415-00

Buzzing Sound From Tweeter Speaker

MODEL:	MODEL YEAR:	VIN:	ASSEMBLY PLANT:	APPLICABILITY:
F-TYPE	2015	K07480	Castle	Coupe
(X152)	Onwards	Onwards	Bromwich

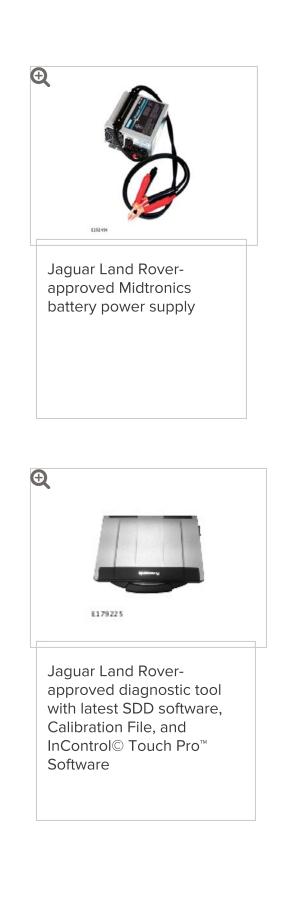
A buzzing sound may be evident from the tweeter speakers.

This may be caused by an Audio Amplifier Module (AAM) software issue.

- Select the Selected Symptoms tab and then select:
 - Electrical Information and entertainment system - Entertainment system - Audio - Audio sound quality poor
- 7 Select **continue**.
- Select the **Recommendations** tab.
- Select Run to perform the 'Configure existing module -Audio amplifier module' option.
- Follow all on-screen instructions to complete this task, ensuring all Diagnostic Trouble Codes (DTC) are cleared.
- When all tasks are complete, select the Session tab and then select the Close Session option.
- Disconnect the diagnostic tool and battery power supply from the vehicle.
